Access Compliance Report

Public Rights-of-Way

(Curb Ramps)

Intersection ID: 13590	Main Street: CAMDEN_RD	Cross Street: S_TRYON_ST	Location: NW
ADA ID: 40F1670EDCBF	Ramp Type: PerpDiag	Initial Pass/Fail: Fail	Overall Compliance: No
Codes/Mitigation Info/Possible Solution		Field Measurements/Component Compliance	
Severity Score: 26.25

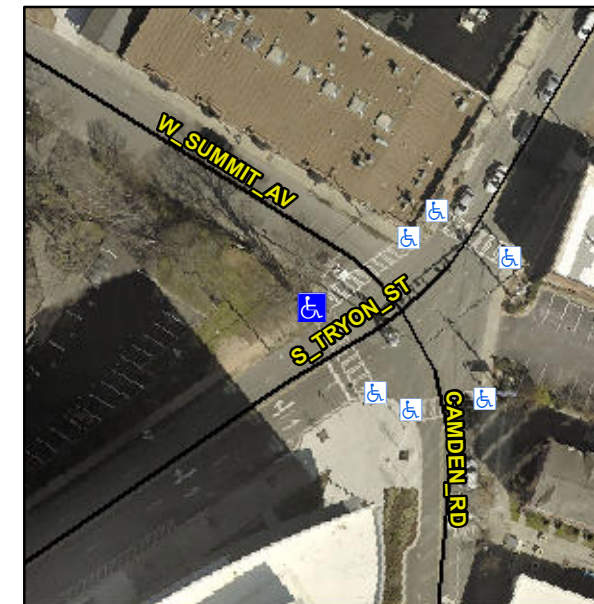
Remove & Replace Curb Ramp With Two New Directional Ramps or Equivalent.

R304.2.2, R304.5.3

Compliance	Description	Data	Compliance	Description	Data
N/A	Ramp Length (in)	52.0	No	Ramp Slope (%)	14.0
Yes	Ramp Width (in)	48.0	No	Ramp XSlope (%)	3.7
N/A	Flare Type LT	N/A	N/A	Flare Type RT	N/A
N/A	Flare Slope LT (%)	N/A	N/A	Flare Slope RT (%)	N/A
N/A	Flare Traversable LT?	N/A	N/A	Flare Traversable RT?	N/A
N/A	Landing Length (in)	N/A	N/A	DWS Provided?	N/A
N/A	Landing Width (in)	N/A	N/A	DWS Contrast?	N/A
N/A	Landing Slope (%)	N/A	N/A	DWS Length (in)	N/A
N/A	Landing X Slope (%)	N/A	N/A	DWS Full Width?	N/A
N/A	Landing Curb? (Y/N)	N/A	N/A	DWS Offset (in)	N/A
N/A	Shared Landing?	N/A			
N/A	Gutter Ponding?	N/A	N/A	Gutter Slope (%)	N/A
N/A	Gutter Lip Ht (in)	N/A	N/A	Gutter X Slope (%)	N/A
N/A	Painted X Walk1?	Yes	N/A	Painted X Walk2?	Yes
	X Walk 1 Direction	To SE		X Walk 2 Direction	To NE
N/A	X Walk 1 Width (in)	98.0	N/A	X Walk 2 Width (in)	106.0
	X Walk 1 Slope (%)	4.3		X Walk 2 Slope (%)	4.7
	X Walk 1 X Slope (%)	2.1		X Walk 2 X Slope (%)	2.5
